HISTORIC AND DESIGN REVIEW COMMISSION

December 20, 2017

HDRC CASE NO: 2017-498
ADDRESS: 1115 NOLAN
LEGAL DESCRIPTION: NCB 1665 BLK 1 17 & W 25 FT OF 16
ZONING: R-6, H
CITY COUNCIL DIST.: 2
DISTRICT: Dignowity Hill Historic District
APPLICANT: Christopher & Lauren Mongeon
OWNER: Christopher & Lauren Mongeon
TYPE OF WORK: Construction of a two story, rear accessory structure and landscaping/hardscaping
APPLICATION RECEIVED: December 01, 2017
60-DAY REVIEW: January 30, 2018
REQUEST:

Site Plan

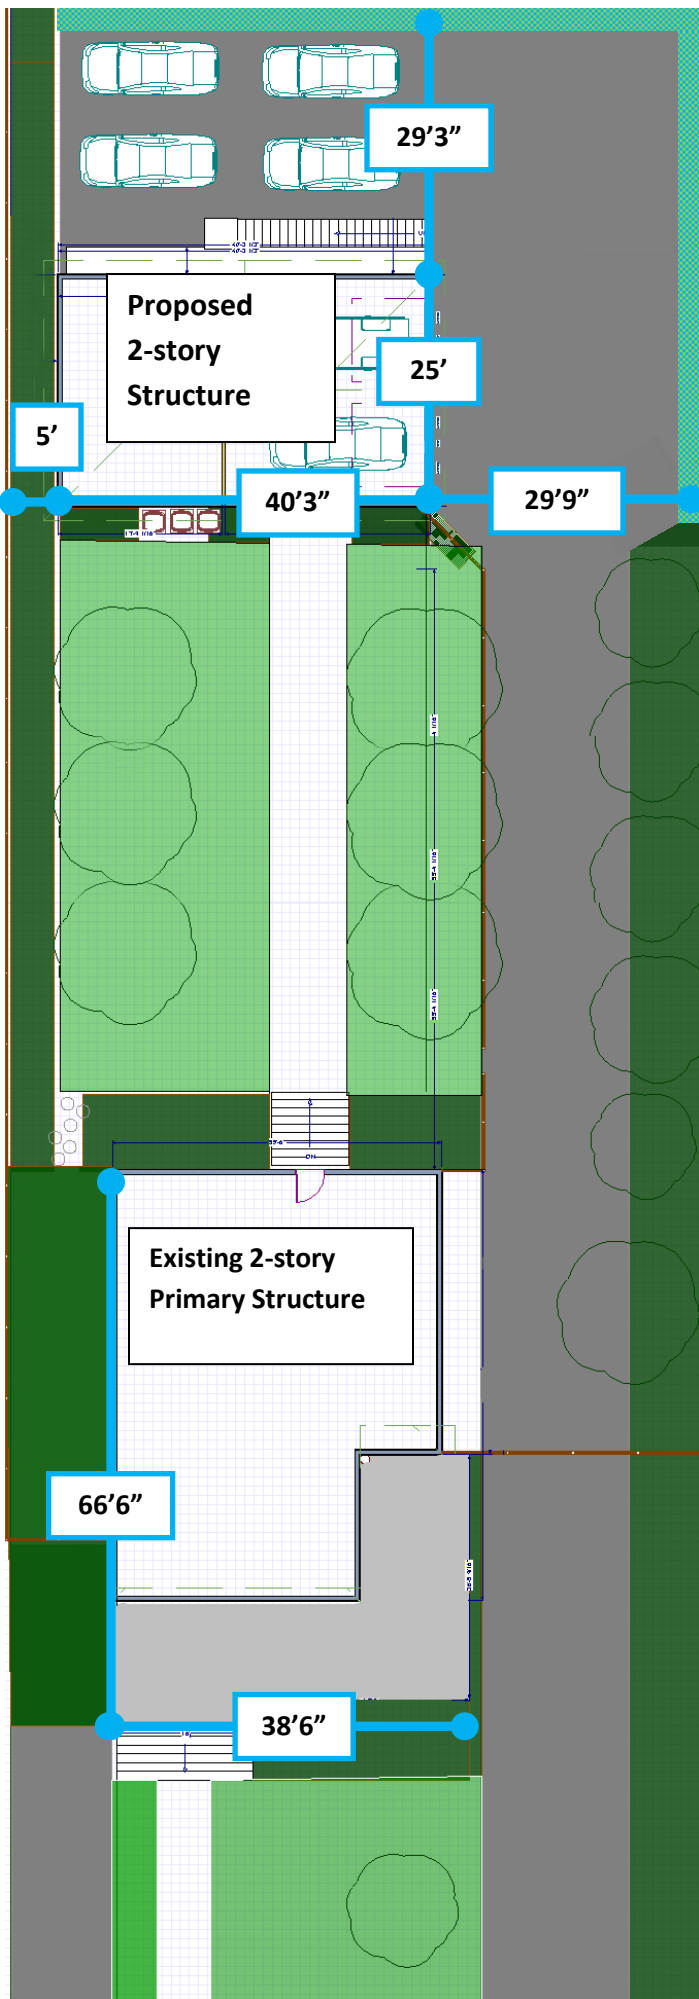
- e. BUILDING SIZE – The Guidelines for New Construction 5.A.ii. notes that new accessory structures should be no larger in plan than forty (40) percent of the primary historic structure's footprint. Per the applicant's provided site plan, the proposed structure's footprint will exceed that which is recommended by the Guidelines. The applicant has proposed a footprint of approximately 1,000 square feet. This is not consistent with the Guidelines. Staff finds that the applicant should reduce the footprint of the proposed structure to be consistent with the Guidelines for New Construction.

- f. SITE MATERIALS – The majority of the rear of the lot is currently covered in concrete paving. The applicant has proposed to reduce the existing amount of concrete paving by adding natural lawn areas between the primary historic structure and the proposed accessory structure. Since conceptual approval, the applicant has incorporated additional landscaping areas and buffers including a perimeter rain garden.

- l. SITE WORK – The property currently features a rear yard that is predominantly concrete. The applicant has proposed to remove portions of the existing concrete and install natural turf and landscaping areas. Staff finds the appropriate.

- i. That the applicant explore ways of minimizing massing and height to the greatest extent possible to result in a rear accessory structure that is consistent with the historic examples found throughout the district as noted in finding d.
- ii. That the applicant reduce the footprint of the proposed structure to be consistent with the Guidelines for New Construction as noted in finding e.
- iii. That all window specifications be adhered to as noted in finding h.
- iv. That the proposed standing seam metal roof feature panels that are 18 to 21 inches in width, seams that are 1 to 2 inches in height, a crimped ridge seam and a standard galvalume finish.
- v. That all Hardi siding feature an exposure of four (4) inches and a smooth finish.

East Facing Elevation, Existing & Proposed Structure

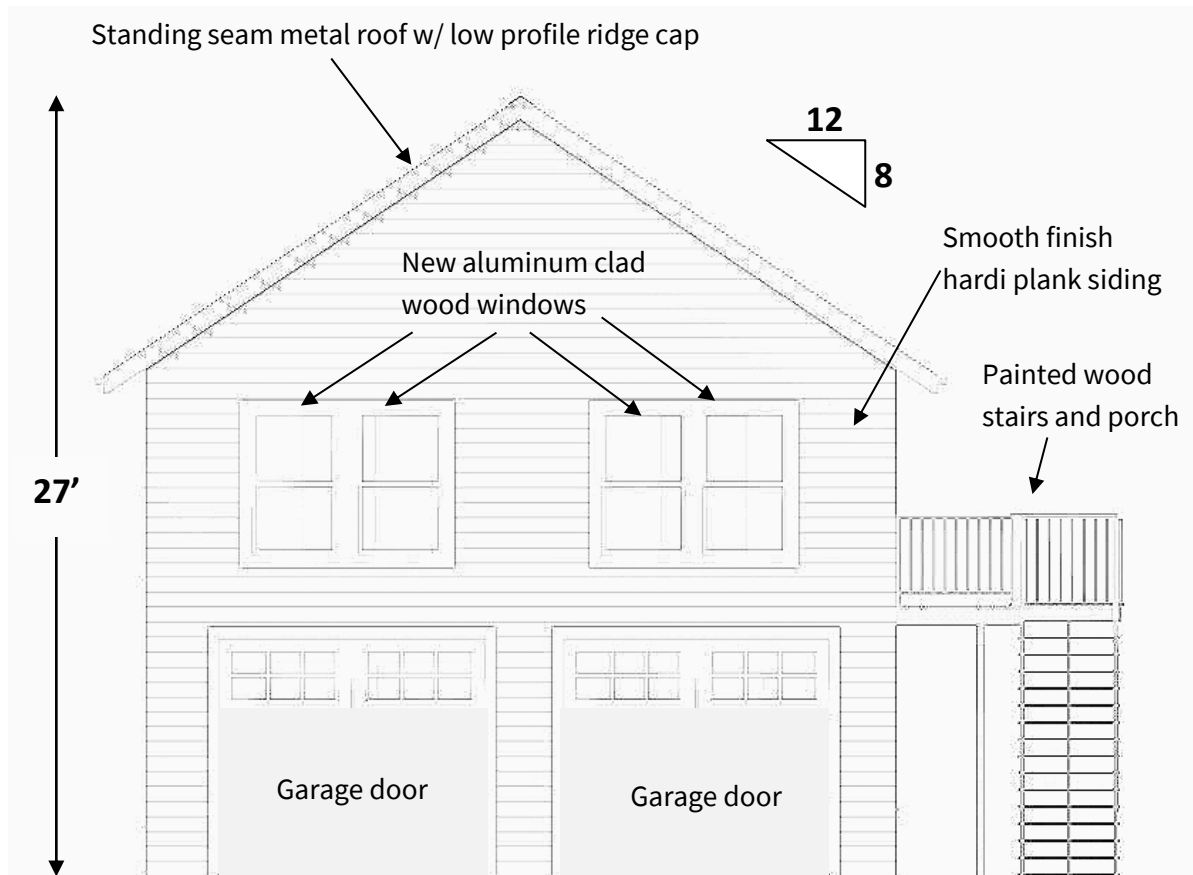
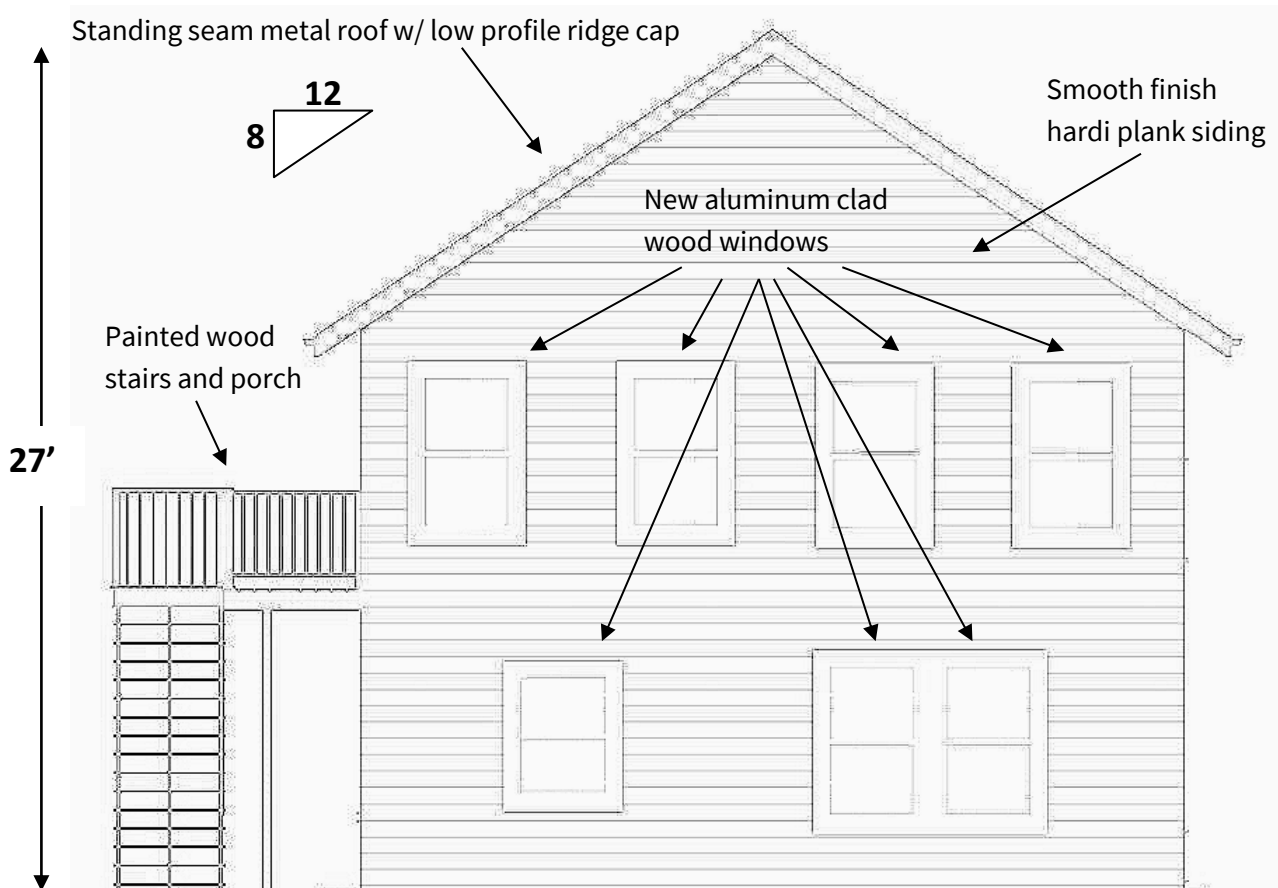
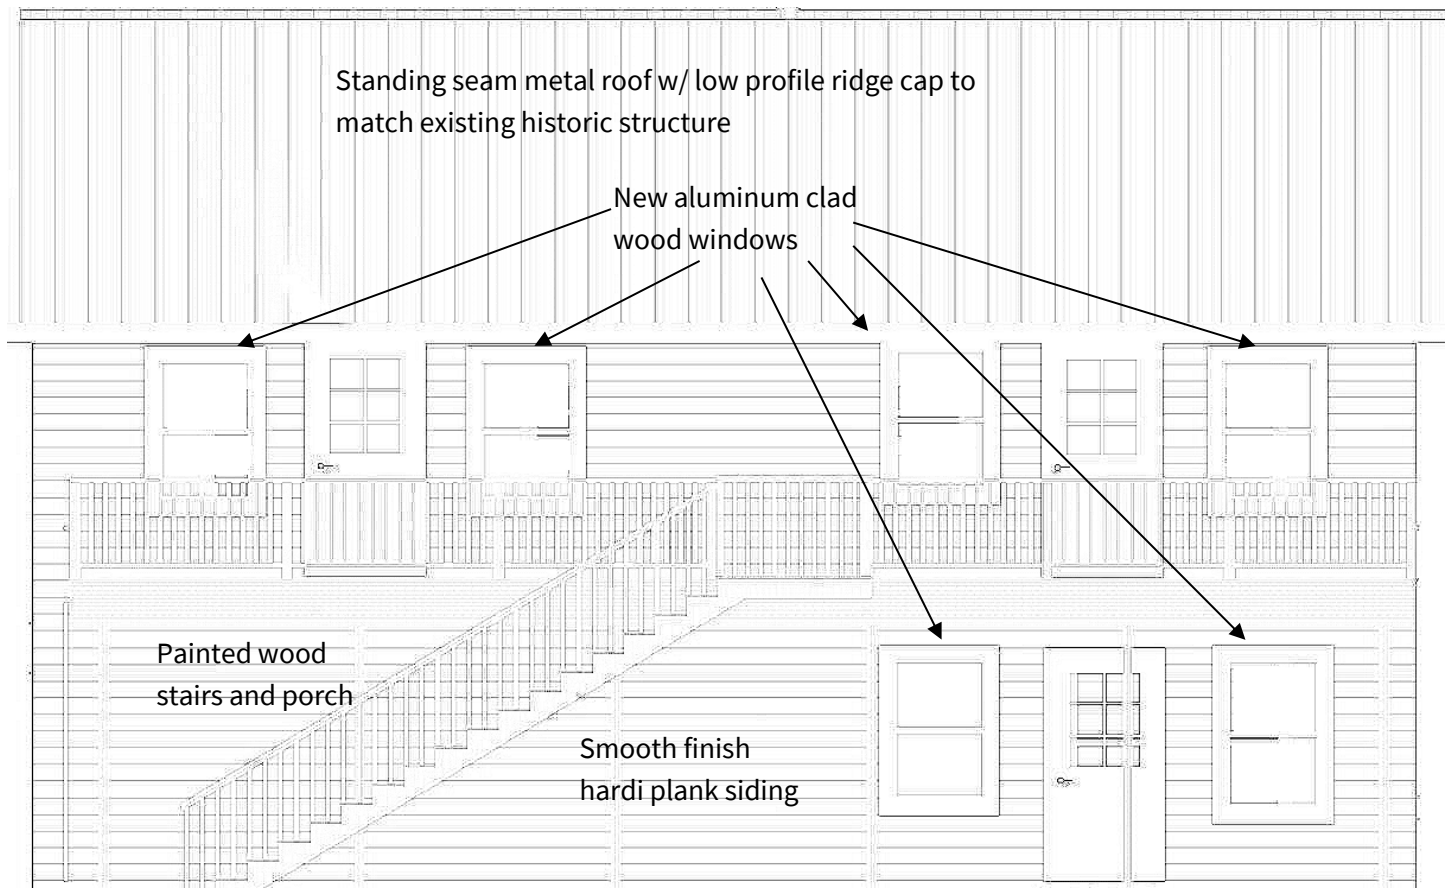
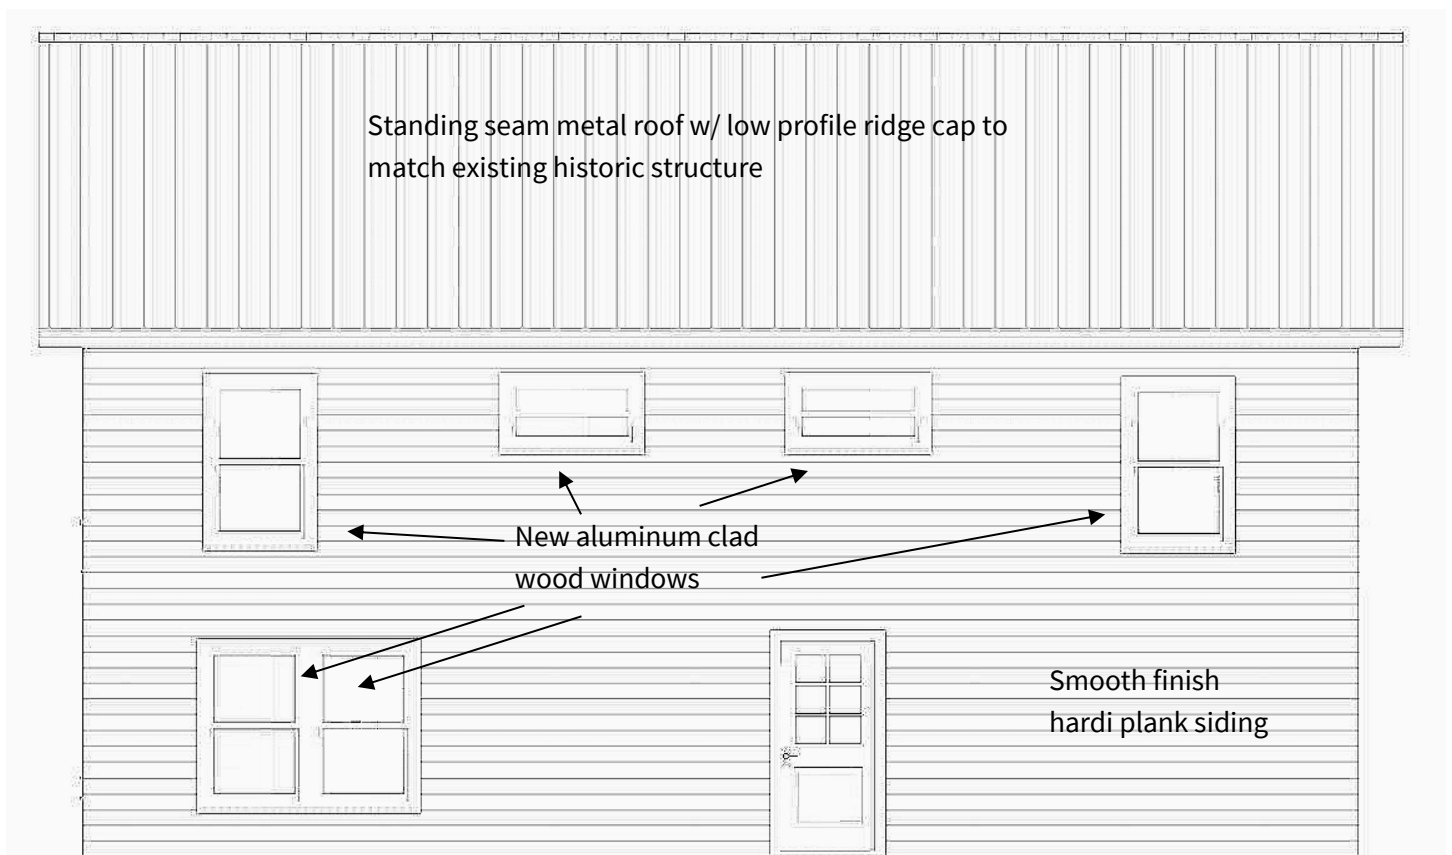
- d. MASSING & FORM – Per the Guidelines for New Construction 5.A.i., new garages and outbuildings should be visually subordinate to the primary historic structure on the lot in terms of their height, massing and form. The applicant has noted an overall height of twenty-seven (27) feet. The primary historic structure features an overall height of thirty-seven (37) feet. Double height accessory structures are not common in the Dignowity Hill Historic District. Staff finds that the construction of a two story rear accessory structure may be appropriate provided that the applicant explore ways of minimizing massing and height to the greatest extent possible. The proposed accessory structure should not be dissimilar to those found historically in the district.
